UNITED STATES PATENT AND TRADEMARK OFFICE

APPLICATION NO.	FILING DATE	FIRST NAMED INVENTOR	ATTORNEY DOCKET NO.	CONFIRMATION NO.
10/025,903	12/26/2001	Kyo Ho Moon	8733.542.00	7621

Office Action Summary	Application No. 10/025,903	Applicant(s) MOON, KYO HO	
	Examiner John M. Parker	Art Unit 2823

Fig. 2

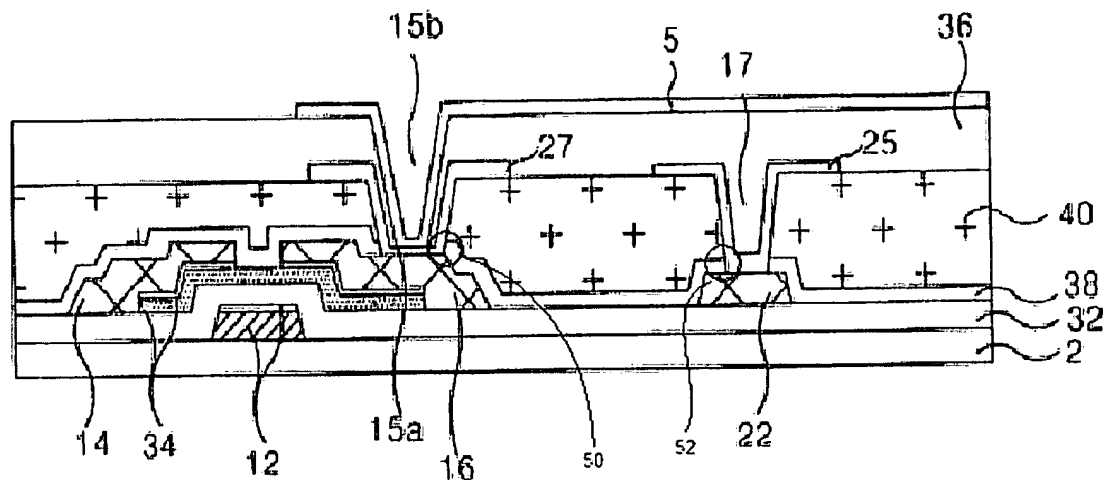
Claims 1-15 are rejected under 35 U.S.C. 102(b) as being anticipated by applicant's admitted prior art (AAPA).

Regarding claim 1, Fig. 2 of AAPA teaches an X-ray detecting device, comprising:

a thin film transistor having a gate electrode [12], a source electrode [14] and a drain electrode [16] provided on a substrate;

a first protective film covering the thin film transistor [38];

a first drain contact hole passing through the first protective film [50];

a second protective film provided on the first protective film [40];

a second drain contact hole passing through the second protective film centering around the drain contact hole [15b]; and

a transparent electrode connected to the drain electrode via the first and second drain contact holes [27, pg. 5, paragraph [0012] confirms it is indeed transparent].

Regarding claim 3, Fig. 2 of AAPA teaches the X-ray detecting device according to claim 1, further comprising: a ground line having the lower electrode of a storage capacitor on the substrate [22];

a first storage contact hole passing through the first protective film covering the ground line [52];

a second storage contact hole passing through the second protective film centering around the first storage contact hole [17];

and a storage electrode electrically connected to the ground line via the first and second storage contact holes [25].

Regarding claim 6, Fig. 2 of AAPA discloses the X-ray detecting device according to claim 5, further comprising: a third protective film provided on the second protective film [36]; and

a pixel electrode electrically connected to the drain electrode via a contact hole passing through the third protective film [5].

Regarding claim 7, Fig. 2 of AAPA teaches the X-ray detecting device according to claim 3, further comprising: a third protective film provided on the second protective film [36]; and

a pixel electrode electrically connected to the drain electrode via a contact hole passing through the third protective film [5].

Regarding claim 9, Fig. 2 of AAPA teaches a method of fabricating an X-ray detecting device, comprising the steps of:

forming a first storage contact hole passing through the first protective film covering the ground line [fig. 2, 52];

forming a second storage contact hole passing through the second protective film centering around the first storage contact hole [fig. 2, 17]; and

forming a transparent electrode on the second protective film [fig. 2, 25, pg. 5, paragraph [0012] confirms it is indeed transparent].

forming a third protective film on the second protective film [fig. 2, 36]; and

forming a pixel electrode on the third protective film [fig. 2, 5].
